Authors' Reply

Reply to Reviewer #1

A cross-scale study for compound flooding processes during Hurricane Florence

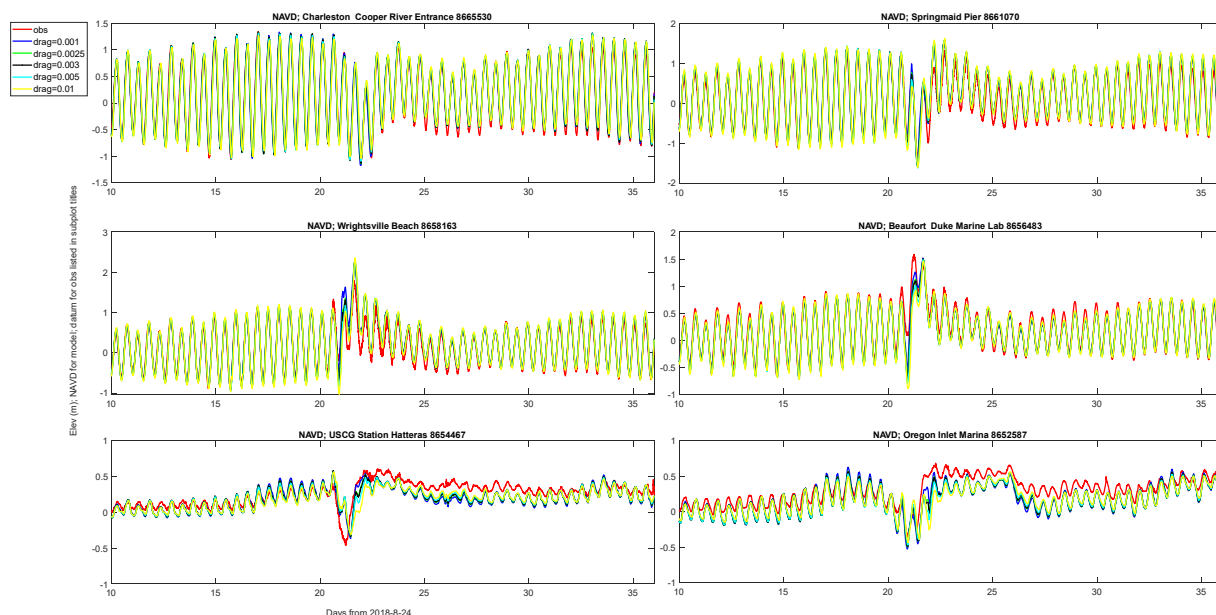
The model is not calibrated. The authors selected a few constant values as the friction values at various locations in the models based on previous studies. Although the authors tried to justify this by saying “in favour of simplicity”, I am not convinced that a model without calibration will be of great value.

We agree with the reviewer that it is not a good statement to say “The tuning of friction values is intentionally kept to minimum in favour of simplicity”. Calibration was indeed an important step during our model setup.

We remove the statement on Line 156-159 (OM) and add more details on calibration (Line 168, RM):

“The friction of the baseline model was tuned in the wet area (river, estuary, ocean; lower than 1 m, NAVD88) and on higher grounds (higher than 3 m, NAVD88) separately. In the wet area, drag coefficients within a range of 0.001-0.01 were tested. Commonly accepted default value of 0.0025 gave good error statistics near the landfall site; but the sensitivity is small in the range of 0.001-0.005.”

“In the watershed, drag coefficients within a range of 0.01-0.5 were tested. The optimal value was chosen based on the High Water Marks (HWMs) comparisons at 276 locations, collected by USGS. A small friction value within this range tended to under-predict the elevation at HWMs, and a large value led to over-prediction. Values within the range of 0.02-0.05 gave good error statistics. We chose 0.025 because it gave slightly better results in the Cape Fear River watershed near the landfall.”

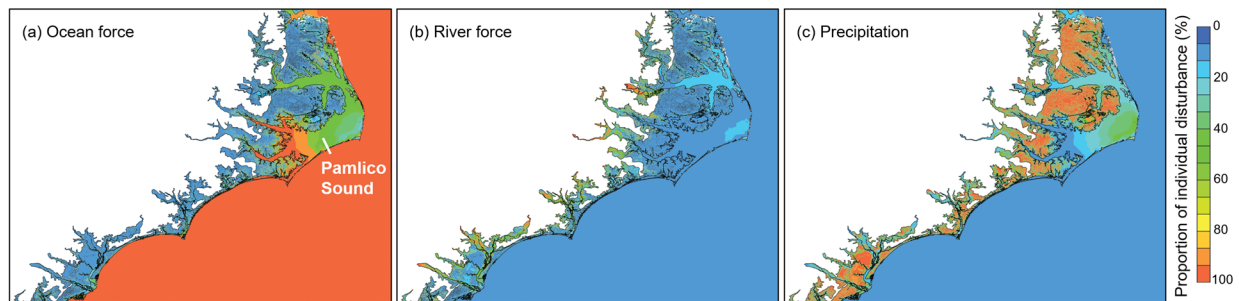
Figure 15. I understand this figure is used to show the impact from different compound flood driver. It is difficult to interpret the results. The caption can include some accompany text on how the figure can be interpreted (what the proportion values imply).

Following the reviewer’s suggestion, we change Fig 15’s caption to:

We also add texts to the labels inside the figure:

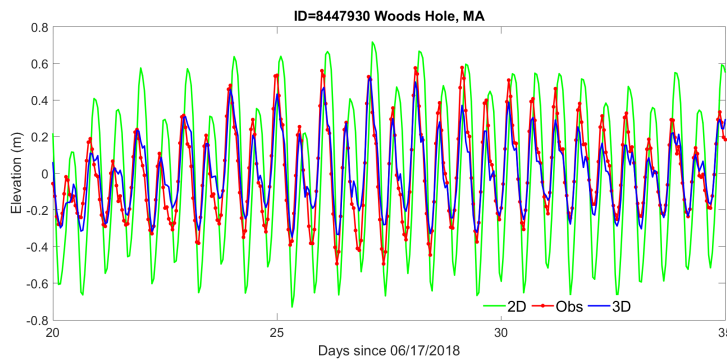
The authors suggest that a 3D baroclinic model is necessary to accurately capture the water level response. However, I suspect that utilizing such a complex model (plus the very large mesh size) would require a very large computational expense. The authors do not present results from using a more simplified approach (2D depth-averaged for example), so we don’t know whether the additional complexity is actually needed to capture the water level response. The manuscript would benefit from some discussion about the trade offs between model complexity and computational burden, as well as some details about how long each simulation takes to run.

We agree with the reviewer and add more texts (before Line 50, OM; Line 49, RM)

“The trade-off between 2D and 3D was carefully weighed with the goal of operationalization in mind before the latter was chosen. In short, the advantage of 2D is the speed (about 80 times faster than its 3D baroclinic counterpart) and the simplicity of the set up; the disadvantage is that it misses baroclinic effects and 3D processes that may become important at certain times and locations. For example, the baroclinic effects during the adjustment phase after Hurricane Irene (2011) are discussed in detail in Ye et al. (2020), using a similar model setup as the one used here. Even though different setups (2D, 3D barotropic, and 3D baroclinic) were tuned to their best possible skills, the 3D baroclinic setup was shown to better capture the total elevation during the post-storm adjustment phase. In addition, during the ongoing effort to operationalize the model, we found that including 3D processes greatly simplified the bottom friction parameterization at some coastal locations (e.g., NOAA Station 8447930 at Woods Hole, MA; Huang et al., submitted). A 3D model can also produce relevant 3D variables (e.g., 3D velocity and tracer concentration) that are important for safe navigation and ecosystem health. The 3D model presented in this paper is efficient enough for operational forecasts (see Section 3.1), which are being set up at NOAA (National Oceanic and Atmospheric Administration).”

The figure below shows the model-data comparison for 2D and 3D with a similar model setup as the current paper. Although it is possible to improve the 2D skill by locally tuning bottom friction, the 3D model achieved good skill without any local tuning. The momentum budget around this location shows that the baroclinic pressure gradient is comparable to the barotropic pressure gradient.

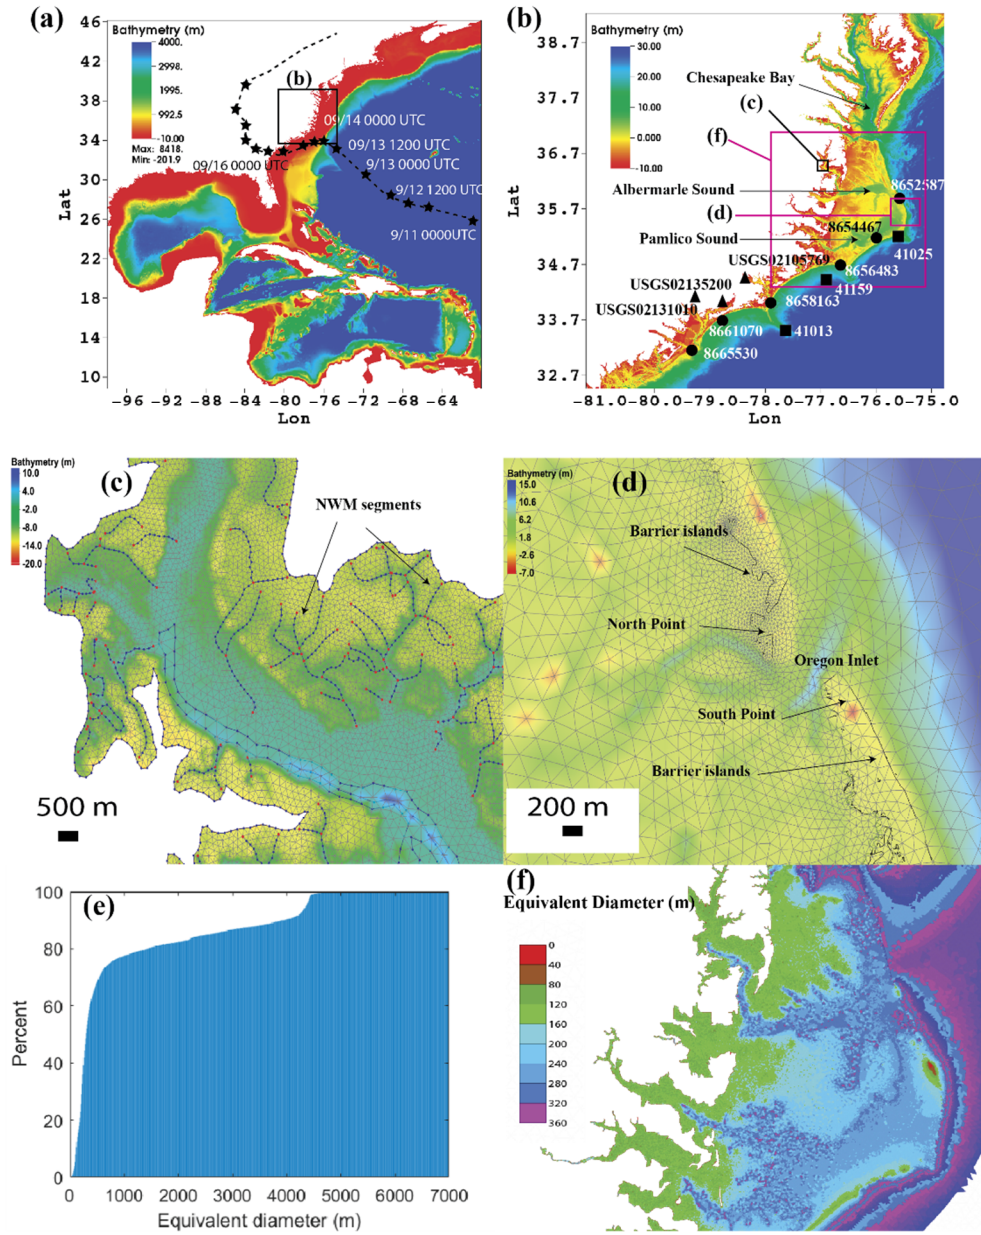
Figure 3: I am a bit confused by figures 3b and 3c. The box showing the location of figure 3c indicates that 3c is north of Albermale Sound. However, when I look at Figure 3c it appears to be depicting the Cape Fear River Estuary, which is at the southern tip of NC. Please confirm/update the actual location of Fig 3c.

Thanks for pointing this out. We have corrected the location of Fig. 3c:

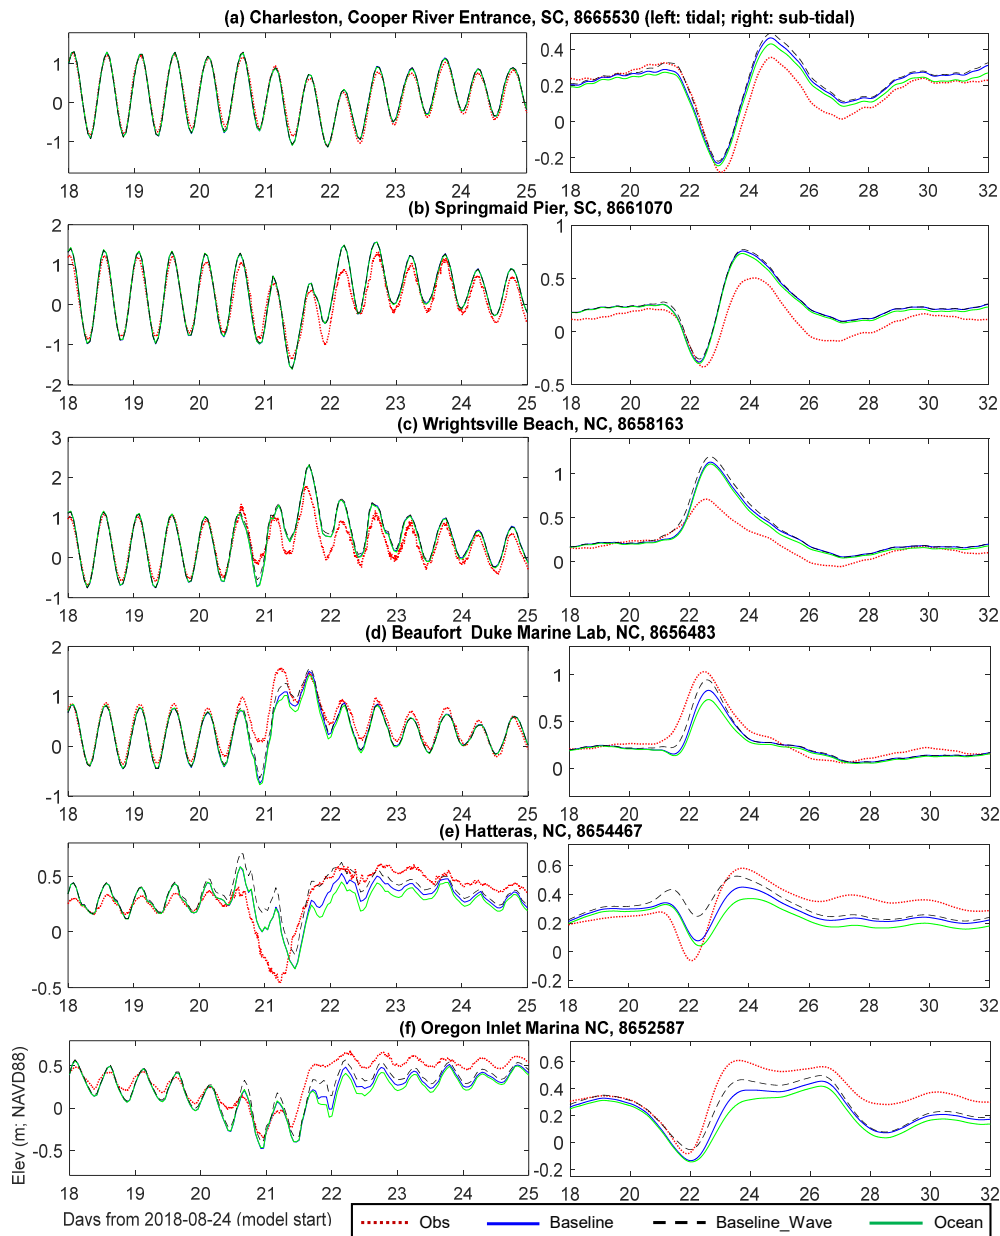
Fig 9: It is difficult to distinguish the differences between the model runs, especially for figures 9a-d. I suggest the authors shorten the depicted time window to only show 1-2 days before landfall through 4-5 days after landfall for a-d. This will allow a reader to see more clearly the differences between the scenarios and the comparison to the observed water levels.

To improve Fig. 9, we shorten the time window, change the line style of the “Baseline_Wave”, and also add sub-tidal comparisons:

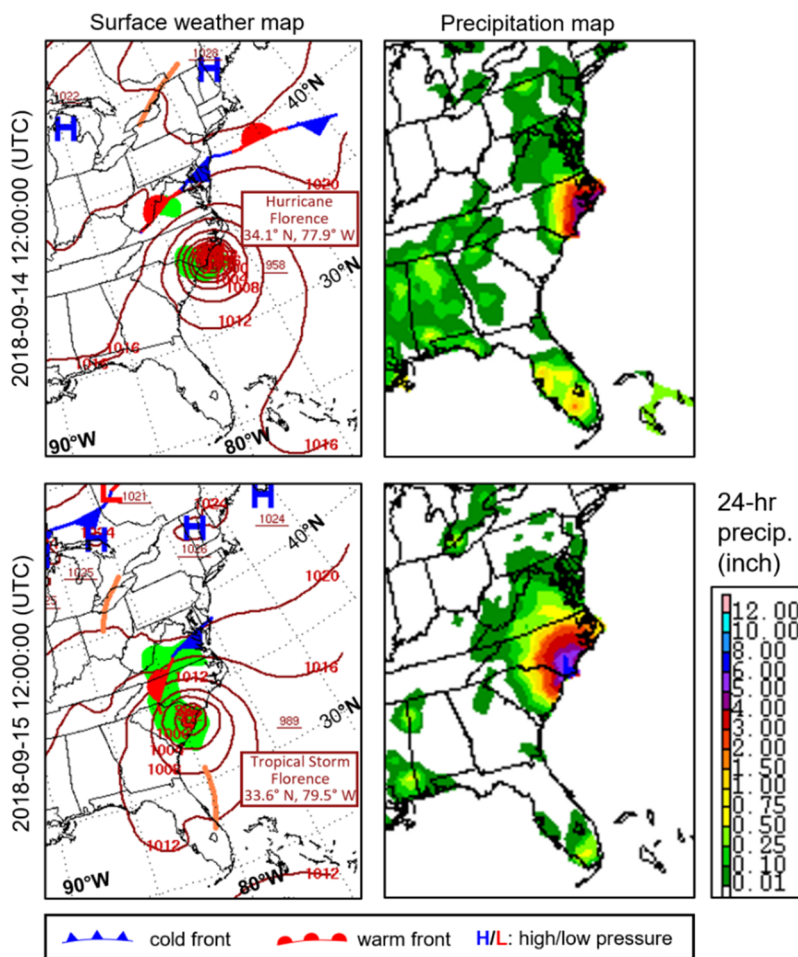
Figure 1: red text (in the left panels) is not readable in print. I'd also add some space between rows in the legend.

Revised as suggested:

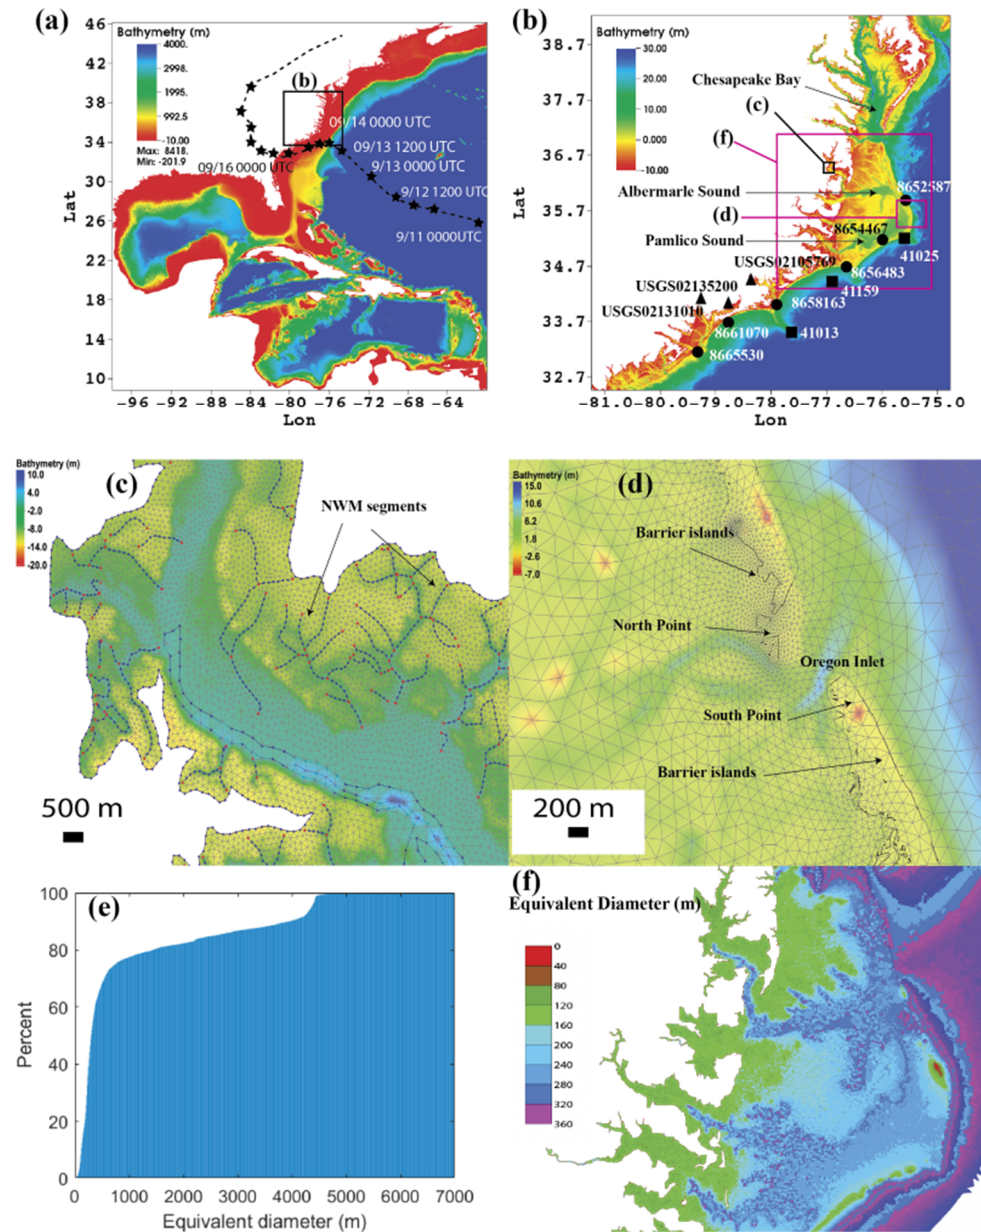
Figure 3: Black text is really hard to read on the dark blue background.

Revised as suggested:

Fig. 4: Vertical grid. (a) Transect from the watershed to the ocean, used to illustrate the vertical grid; (b) vertical grid along the transect; (c) zoom-in from (b), illustrating the transitions from 3D (Pamlico Sound) to 2DH (barrier island) and back to 3D (coastal ocean).

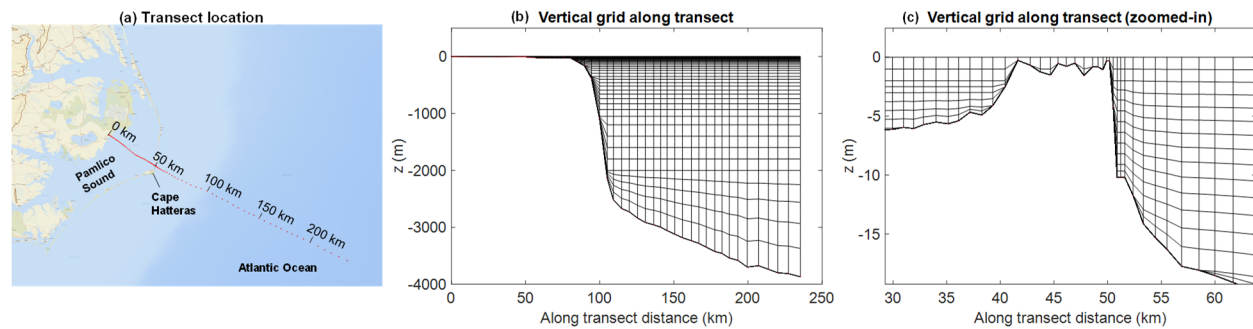
Figure 4 is confusing. Hurricane track is numbered right-to-left (Panel a) and vertical grid points are numbered Left-to-Right (Panels b and c)

Revised as suggested. The numbered points are removed and the transect is more clearly defined with along-transect distance marked in all subplots.

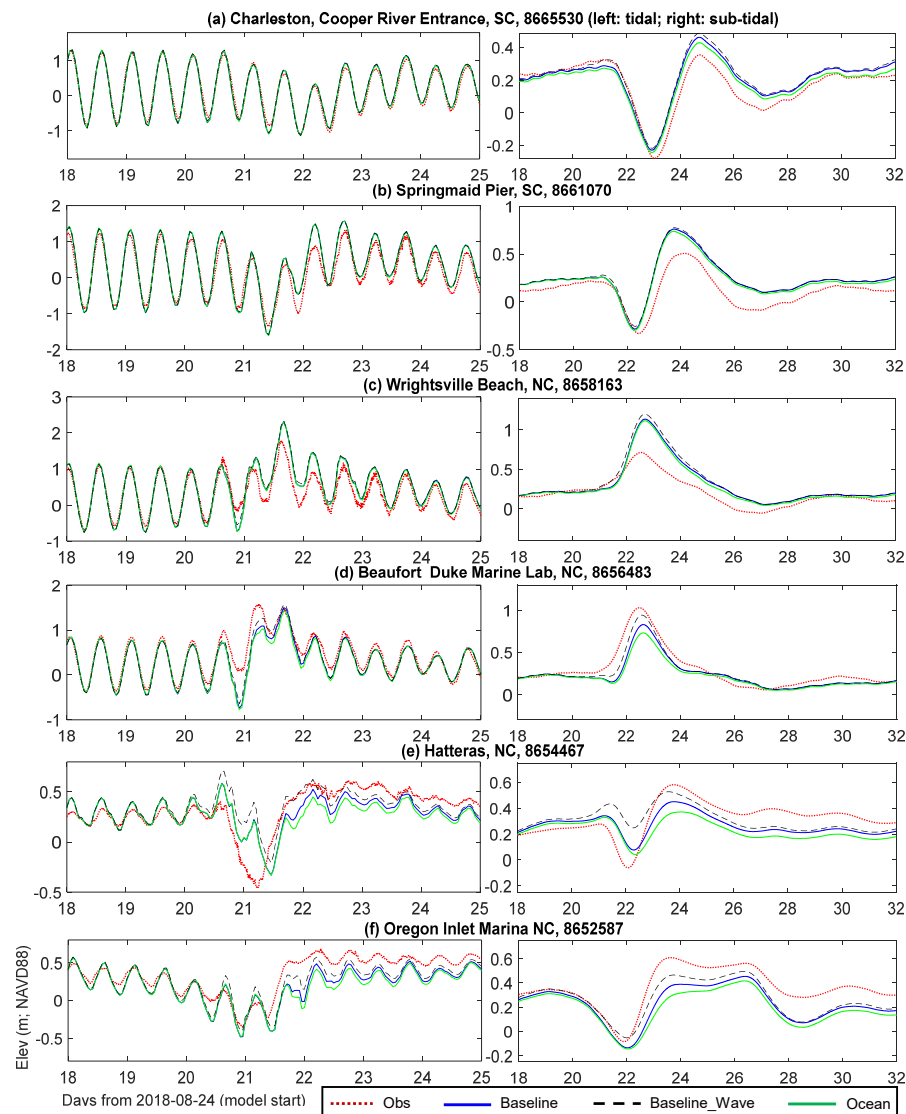
Figure 9: Better to compare detided signal here. These gauges are extremely tidal influenced and estimation skills of the model for stochastic processes is diluted by highly predictable astronomic tides.

We agree that de-tided signal will give a clearer picture of stochastic processes. We add new sub-plots on sub-tidal signals (see the figure below) to Fig. 9.

(Line 242, OM; Line 292, RM) “..., as seen from the total elevation (Fig. 9a) and the sub-tidal signals (Fig. 9b). The latter applies a low-pass Butterworth filter (Butterworth, 1930) only preserving longer-period (longer than 2 days) components.”

(Line 251, OM; Line 302, RM) “The mechanism causing the water level set-downs at the two South Carolina stations is similar to that causing the set-downs behind the barrier islands in North Carolina. The two South Carolina stations (Charleston and Springmaid) are located to the south of the landfall site and the wind direction is from the land to the ocean, pushing water away from shore.”

(Line 253, OM; Line 306, RM) “The averaged MAE for the subtidal comparison is 8.6 cm and averaged correlation coefficient is 0.92.”

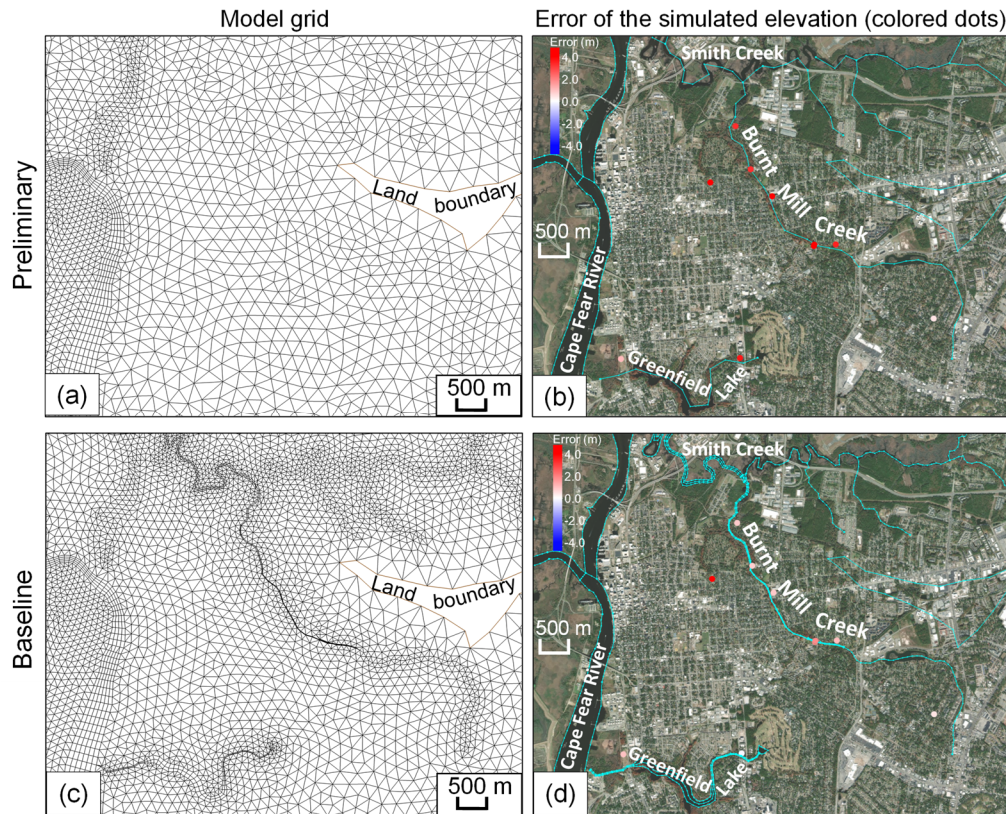
We found a minor problem with Fig. 13d and fixed it in the new Fig. 13 (shown below) and Fig. 1d. Specifically, a different run other than the baseline model was used to plot Fig. 13d in the original manuscript, which has been corrected. This does not change the conclusion that resolving small-scale flow routing features greatly improves the prediction of HWM elevation. The “Burnt Mill Creek” was mislabeled as “Northeast Cape Fear River” in the original manuscript, which has been corrected. Lake Greenfield and more labels were also added for better illustration.

Fig. 11: Comparison of HWMs. (a) Field estimates from USGS; (b) model prediction; (c) model minus observation; (d) regression between model prediction and observation; (e) histogram showing the error distribution.

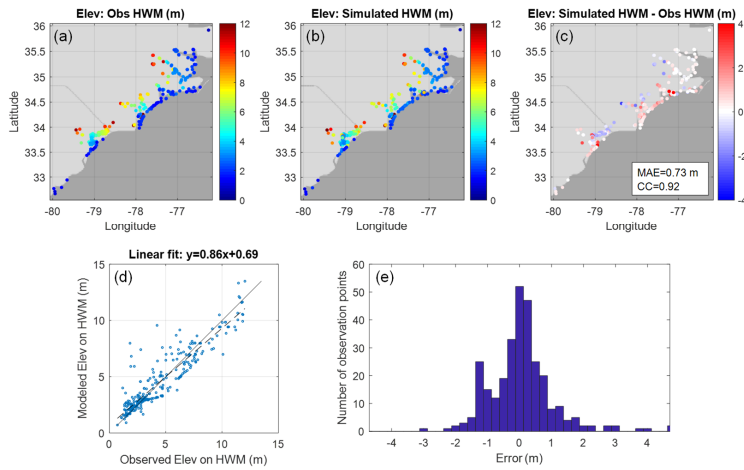
Figure 11: The figure shows modelling errors of up to +/-4 meters at various locations. Do the authors have an explanation on the large errors at these locations (apart from just saying calibration can improve model

performance)? - The authors did a good job explaining model performance in relation to grid resolution. A similar explanation here will be good.

In short, the few large errors are likely the result of similarly **under-resolved bathymetric/topographic features** or the **neglect of drainage system in the urban area**, with minor contributions from other factors such as the uncertainties in the NWM prediction and DEM. We add more explanations into the revised manuscript:

[Line 184, OM; Line 221, RM]: “As another model limitation, the drainage in urban settings is not included in our model. This may have led to some occasional big errors in the predicted elevation on high water marks, for example the one large error in the urban area in Fig. 13d. We do have a plan of explicitly accounting for infiltration and drainage as volume sinks based on NWM (or other hydrologic models). However, considering the additional uncertainty this would bring, for now we choose to continue improving more important aspects of the model for operational use; the focus is on the quality of model grid, which is very likely responsible for most of the existing large errors.”

[Line 293, OM; Line 357, RM]: “Our tests show that the simulated elevation on the High Water Marks (HWMs) in the watershed is sensitive to: grid resolution, precipitation, river inputs through the land boundary, and bottom friction. Grid resolution and quality is the most important factor, as explained in the last paragraph of Section 4.3. Misrepresenting flood pathways can easily lead to errors of a few meters near some very localized features like ditches, highways etc. ... The defects in grid quality can lead to large errors that are not likely to be rectified by tuning other parameters. To fix the remaining few large errors away from the landfall site, grid quality should be examined first. The continuous improvement on this model grid is part of an ongoing effort of operationalizing the model along the US East Coast and Gulf Coast, and we will report this in future studies. ... Afterwards, the inclusion of urban drainage should reduce the occasional large errors there (Fig. 13d). Other factors such as uncertainties in DEM, precipitation and the river flow through land boundary also play minor roles.”

[Line 300-302, OM; Line 364, RM] The only remaining large error in the “baseline” occurs in an urban area away from the river, likely due to the building or drainage effects that have not been incorporated in the model (Fig. 13d).
